Access Compliance Report

Public Rights-of-Way

Intersection ID: 23166	Main Street: LAUREL_POINTE_WY	Cross Street: LAUREL_VIEW_DR	Location: SW
ADA ID: D105AAFDE798	Ramp Type: Perp	Initial Pass/Fail: Fail	Overall Compliance: No
Severity Score: 12.5			
Codes/Mitigation Info/Possible Solution		Field Measurements/Component Compliance

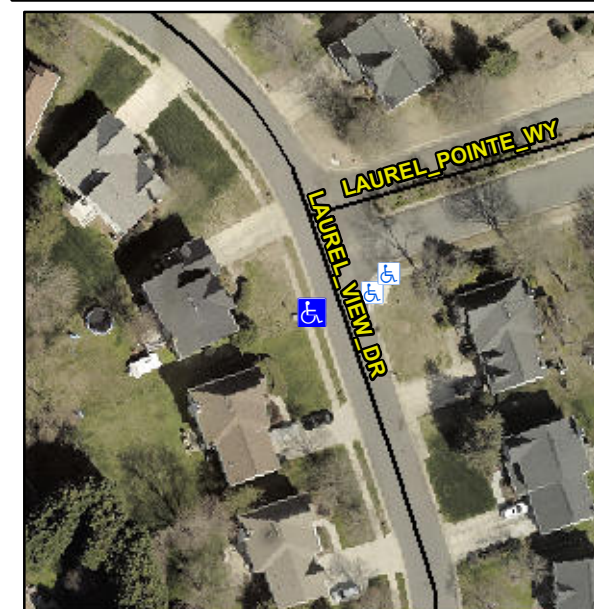
Not Found, R304.2.2

Compliance	Description	Data	Compliance	Description	Data
N/A	Ramp Length (in)	47.0	No	Ramp Slope (%)	8.8
Yes	Ramp Width (in)	48.0	Yes	Ramp XSlope (%)	1.5
N/A	Flare Type LT	N/A	N/A	Flare Type RT	N/A
N/A	Flare Slope LT (%)	N/A	N/A	Flare Slope RT (%)	N/A
N/A	Flare Traversable LT?	N/A	N/A	Flare Traversable RT?	N/A
N/A	Landing Length (in)	N/A	N/A	DWS Provided?	N/A
N/A	Landing Width (in)	N/A	N/A	DWS Contrast?	N/A
N/A	Landing Slope (%)	N/A	N/A	DWS Length (in)	N/A
N/A	Landing X Slope (%)	N/A	N/A	DWS Full Width?	N/A
N/A	Landing Curb? (Y/N)	N/A	N/A	DWS Offset (in)	N/A
N/A	Shared Landing?	N/A			
N/A	Gutter Ponding?	N/A	N/A	Gutter Slope (%)	N/A
N/A	Gutter Lip Ht (in)	N/A	N/A	Gutter X Slope (%)	N/A
N/A	Painted X Walk1?	No	N/A	Painted X Walk2?	N/A
	X Walk 1 Direction	To E		X Walk 2 Direction	N/A
N/A	X Walk 1 Width (in)	N/A	N/A	X Walk 2 Width (in)	N/A
	X Walk 1 Slope (%)	2.5		X Walk 2 Slope (%)	N/A
	X Walk 1 X Slope (%)	0.7		X Walk 2 X Slope (%)	N/A

Remove & Replace Entire Ramp.
